MISSISSIPPI DEPARTMENT OF TRANSPORTATION

| SPECIAL PROVISION NO. 907-413-5

SUBJECT: Sawing and Sealing Transverse Joints in Asphalt Pavement

DETAIL OF SAWING AND SEALING TRANSVERSE JOINTS

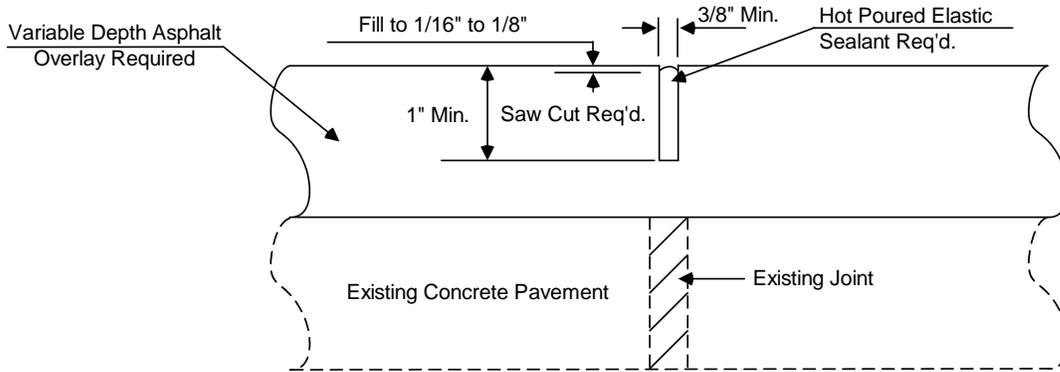
The Contractor's operation shall be conducted so that sawcutting of transverse joints, cleaning, and sealing is a continuous operation. The entire sawing and sealing operation shall be completed within seven (7) days after the placement of the final wearing course, unless the approved traffic control plan or sequence of operations provide otherwise. Traffic shall not be allowed on sawed unsealed joints in the final wearing course.

When intermediate lifts must be exposed to traffic for over seven (7) days, the Contractor shall be required to make an interim 1/8-inch wide saw cut which is one third (1/3) as deep as the asphalt layer. This interim saw cut does not require sealing. Costs of any interim cut(s) shall be included in the pay item for sawing and sealing transverse joints in asphalt pavement.

The detail for sawing and sealing transverse joints in asphalt pavement shall be as shown below. No sawing and sealing of transverse joints will be required in Open Graded Friction Courses (OGFC). However, the lift under the OGFC will require sawing and sealing.
